ADDENDUM NO. 2

PACIFIC HIGH SCHOOL – NEW ADMINISTRATION BUILDING

SAN BERNARDINO CITY UNIFIED SCHOOL DISTRICT

DSA No. 04-119637 File No. 36-H7 RCA Job No. 1-78-28

LEVEL 1 FLOOR PLAN - POWER

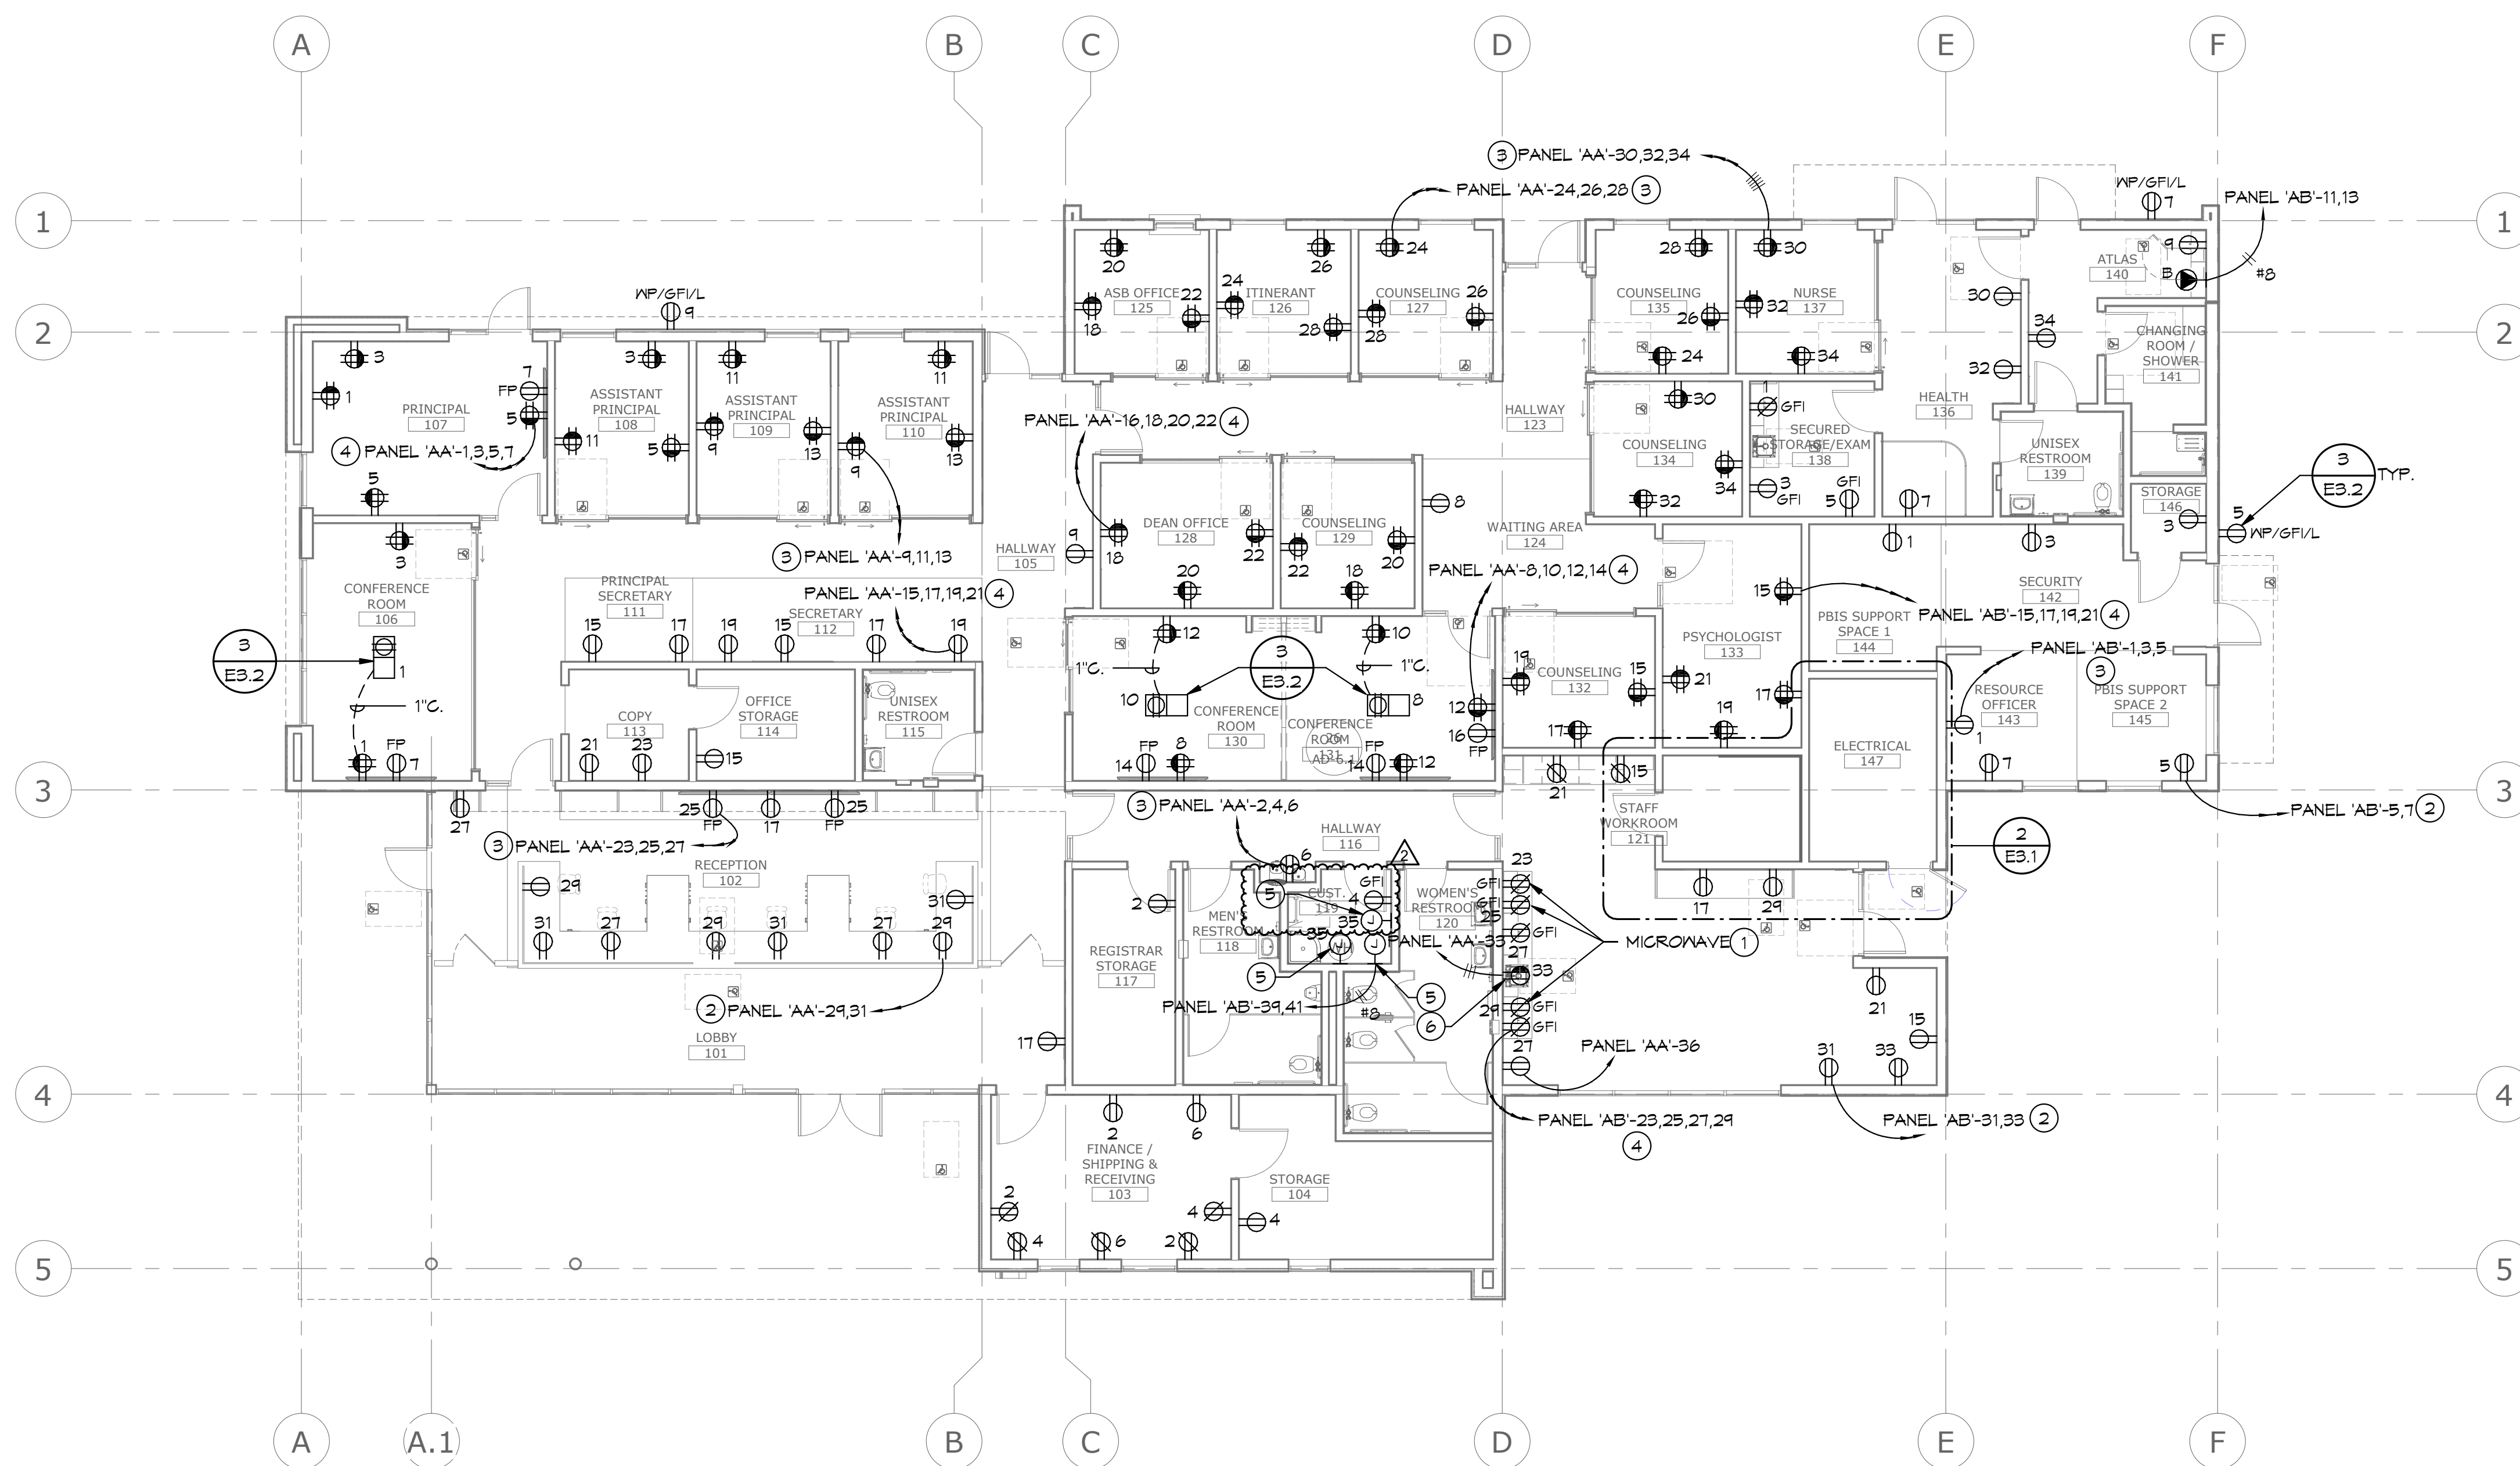
- Item No. 2.21 Reference Sheet E3.1:
2.21.1 Revise power for mechanical & plumbing panels, per clouded areas of attached revised Sheet E3.1
- Item No. 2.22 Reference Sheet E4.1:

COMMUNICATIONS
FLOOR PLAN

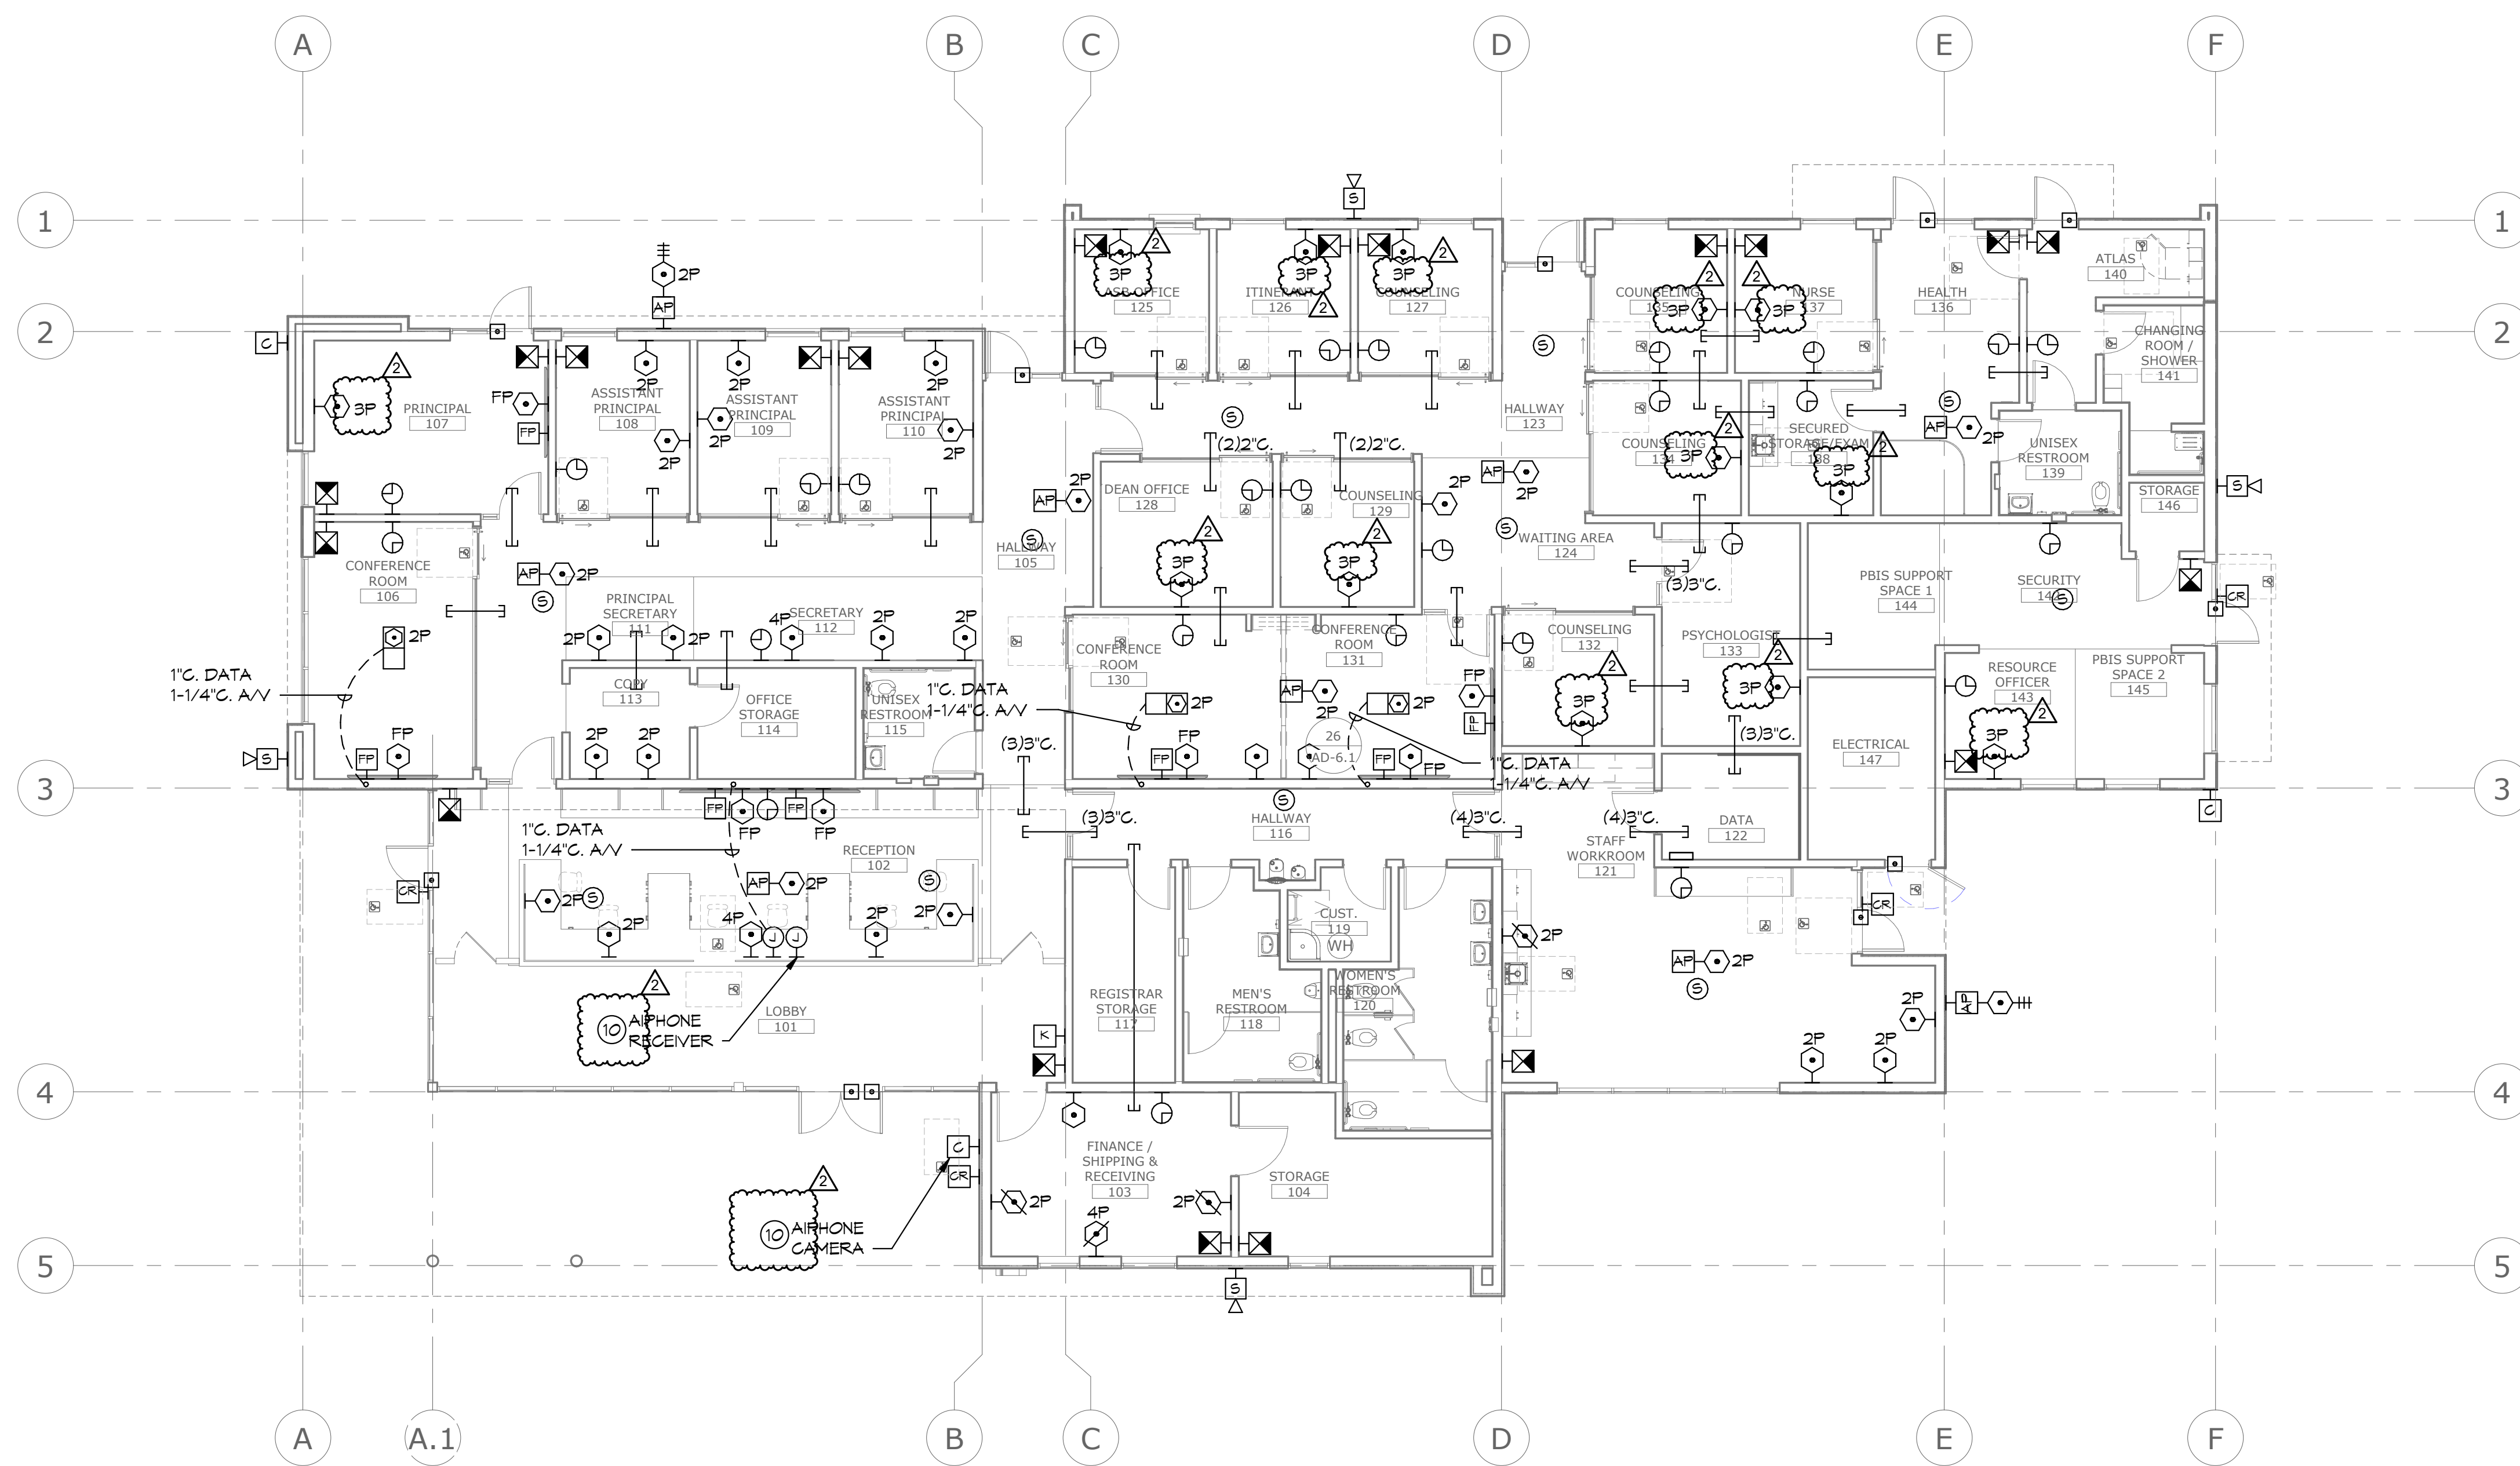
2.22.1 Revise per clouded areas of attached revised Sheet E4.1:
 a. Added Keynote #10, for data connection to "Aiphone" camera/receiver
 b. Revised quantity of data ports in offices
